MIL-C-25955(USAF)
AMENDMENT 3
5 February 1960

MILITARY SPECIFICATION

CONNECTORS, ELECTRICAL, ENVIRONMENT RESISTING

MINIATURE, WITH SNAP-IN CONTACTS

Figure 1 CONTACTS

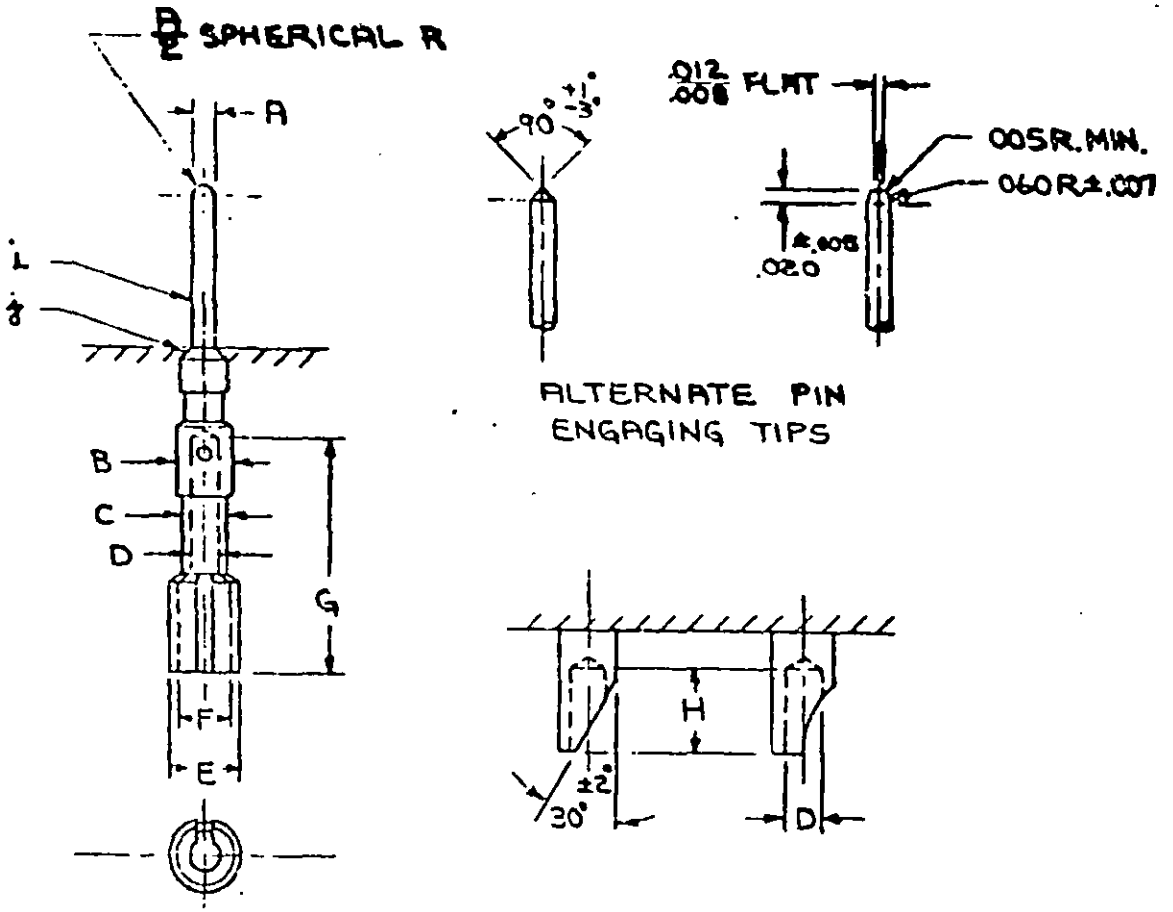
Page 6, figure 1: Delete and substitute the attached figure 1 which forms page 2 of this amendment.
